# Access Compliance Report

## Public Rights-of-Way

### (Curb Ramps)

Intersection ID: 10027413	Main Street: GOLF_LINKS_DR_N	Cross Street: N/A	Location: SE
ADA ID: E8243B18913E	Ramp Type: Perp	Initial Pass/Fail: Fail	Overall Compliance: No
Severity Score: 1.25			
Codes/Mitigation Info/Possible Solution		Field Measurements/Component Compliance

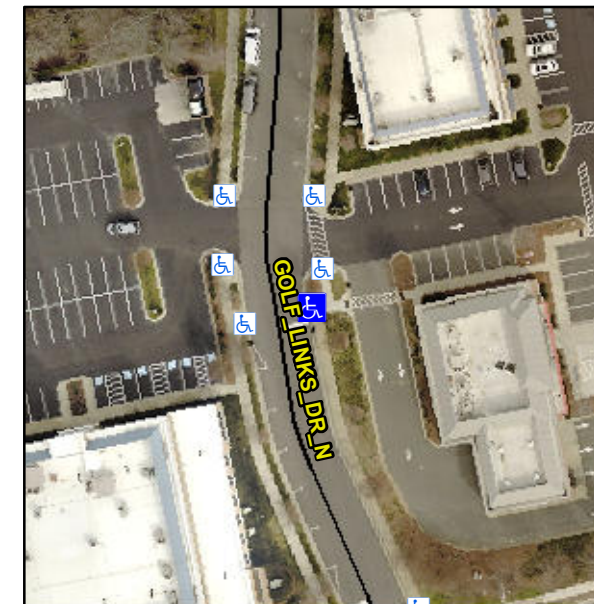
**Not Found, R304.5.3**

Compliance	Description	Data	Compliance	Description	Data
N/A	Ramp Length (in)	60.0	Yes	Ramp Slope (%)	7.3
Yes	Ramp Width (in)	62.0	No	Ramp XSlope (%)	2.3
N/A	Flare Type LT	N/A	N/A	Flare Type RT	N/A
N/A	Flare Slope LT (%)	N/A	N/A	Flare Slope RT (%)	N/A
N/A	Flare Traversable LT?	N/A	N/A	Flare Traversable RT?	N/A
N/A	Landing Length (in)	N/A	N/A	DWS Provided?	N/A
N/A	Landing Width (in)	N/A	N/A	DWS Contrast?	N/A
N/A	Landing Slope (%)	N/A	N/A	DWS Length (in)	N/A
N/A	Landing X Slope (%)	N/A	N/A	DWS Full Width?	N/A
N/A	Landing Curb? (Y/N)	N/A	N/A	DWS Offset (in)	N/A
N/A	Shared Landing?	N/A			
N/A	Gutter Ponding?	N/A	N/A	Gutter Slope (%)	N/A
N/A	Gutter Lip Ht (in)	N/A	N/A	Gutter X Slope (%)	N/A
N/A	Painted X Walk1?	No	N/A	Painted X Walk2?	N/A
	X Walk 1 Direction	To W		X Walk 2 Direction	N/A
N/A	X Walk 1 Width (in)	N/A	N/A	X Walk 2 Width (in)	N/A
	X Walk 1 Slope (%)	2.9		X Walk 2 Slope (%)	N/A
	X Walk 1 X Slope (%)	0.7		X Walk 2 X Slope (%)	N/A

**Remove & Replace Entire Ramp.**
